# SERVICE BULLETIN

Classification: AT10-006	Reference: NTB11-011	Date: February 18, 2011
-----------------------------	-------------------------	----------------------------

## 2009 - 2011 GT-R MIL "ON" WITH DTC P0729/P2832 STORED

**APPLIED VEHICLE:** 2009 – 2011 GT-R (R35)

Figure 13

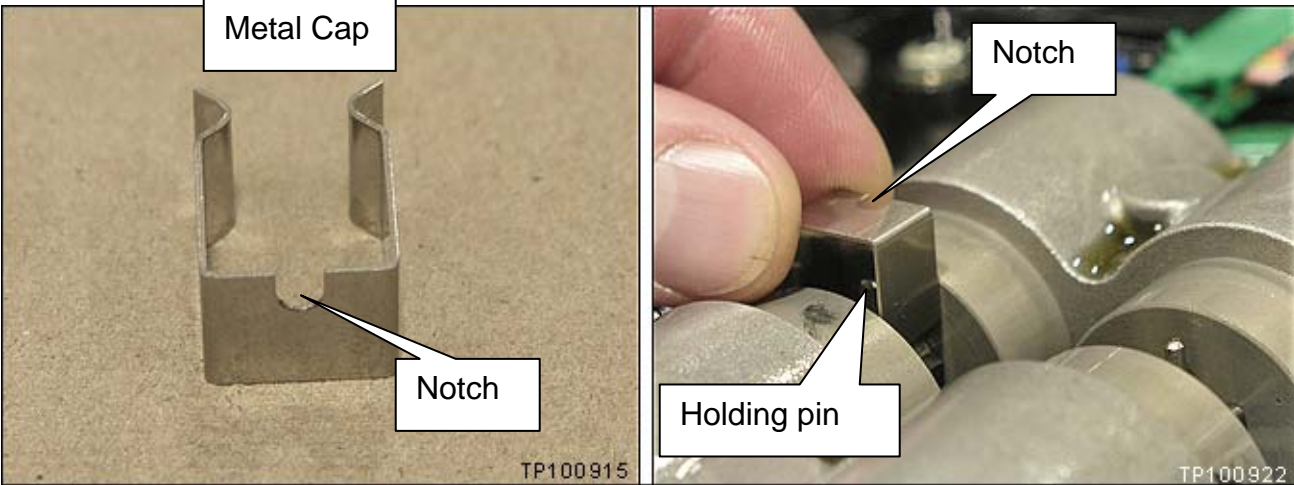
15. Install a Metal Cap onto 3 of the ACM shift pistons.

- Make sure the notch is aligned with the retaining pins.

Figure 14

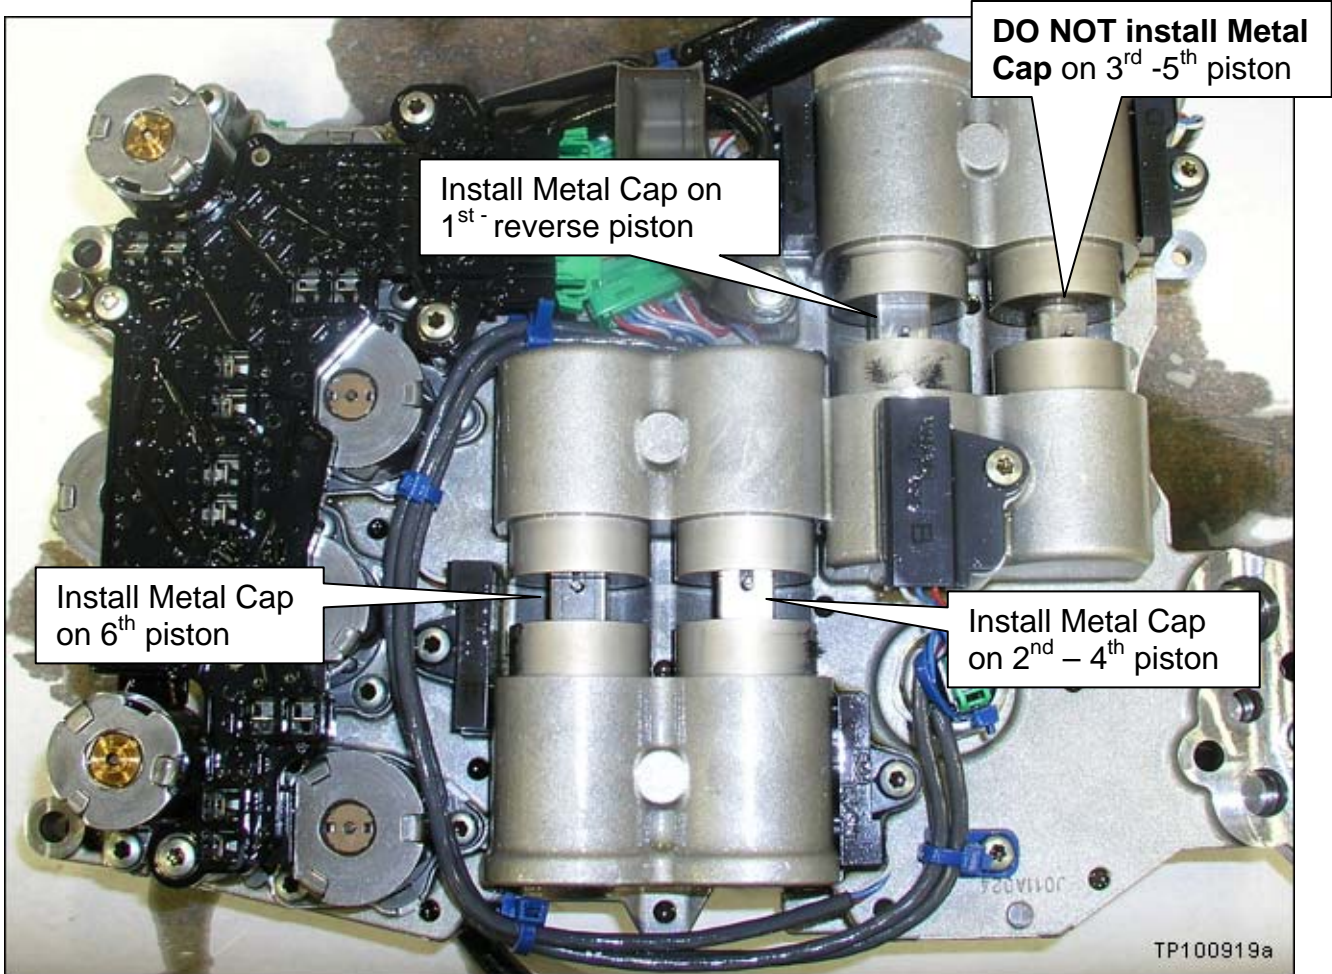
- Install Metal Caps on the 3 pistons shown in Figure 14.
